Project	IEEE 802.16 Broadband Wireless Access Working Group < http://ieee802.org/16 >	
Title	Enhanced Feedback Method for Enhanced FAST_FEEDBACK channels	
Date Submitted	2004-11-15	
Source(s)	Hang Zhang, Mo-Han Fong, Peiying Zhu, Wen Tong	mhfong@nortelnetworks.com
	Nortel Networks	Voice: +1-613-765-8983
	3500 Carling Avenue, Ottawa	Fax: +1-613-765-6717
	Ontario, Canada K2H 8E9	
Re:	IEEE P802.16e/D5-2004	
Abstract	This contribution proposes to enhance the feedback content on CQICH. This is a revised contribution. Changes are highlighted in blue.	
Purpose	Review and Adopt the suggested changes into P802.16e/D5	
Notice	This document has been prepared to assist IEEE 802.16. It is offered as a basis for discussion and is not binding on the contributing individual(s) or organization(s). The material in this document is subject to change in form and content after further study. The contributor(s) reserve(s) the right to add, amend or withdraw material contained herein.

Figure yyy Mapping of feedback information on CQICHs

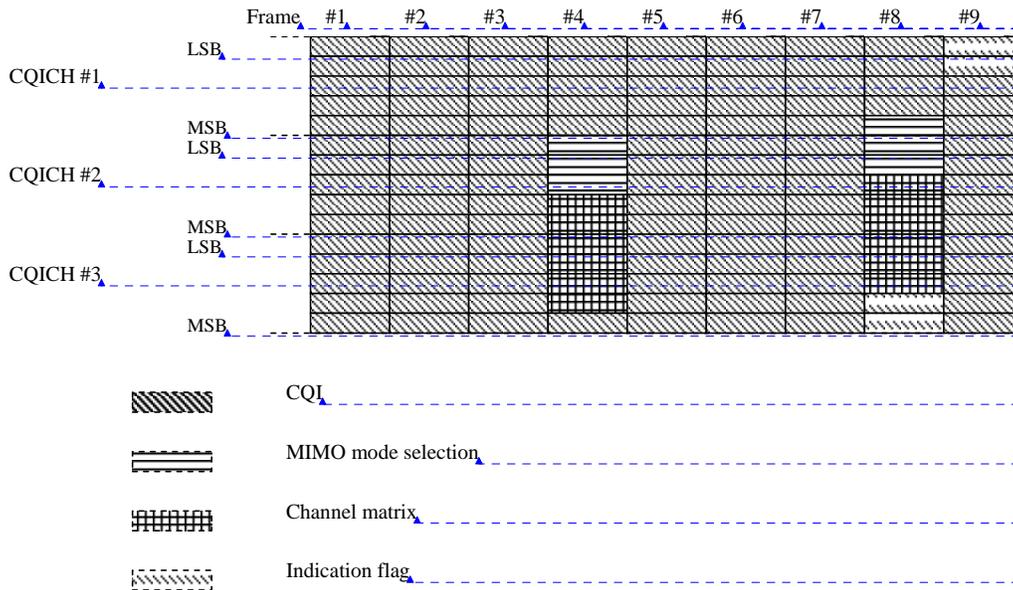
The following example is given as an illustration. The MSS is assigned 3 6-bit CQICHs every frame. The 5 LSB of each CQICH is used to carry the feedback information. The MSS is required to feedback 3 types of information: 5-bit average CQI, 3-bit MIMO mode selection, and 6-bit channel matrix. The feedback cycle is defined as 10 average CQI feedback, followed by 1 MIMO mode selection feedback and followed by 1 channel matrix feedback. An indication flag is inserted every 2 feedback cycles. Figure yyy below illustrates how the feedback information is mapped to the CQICHs resource.

Upon receiving the Feedback Request IE(), the MSS shall transmit the feedback information indicated by the Feedback types, on the assigned CQICH resource. The MSS shall map the feedback information sequentially on the payload bits of the assigned CQICHs resource.
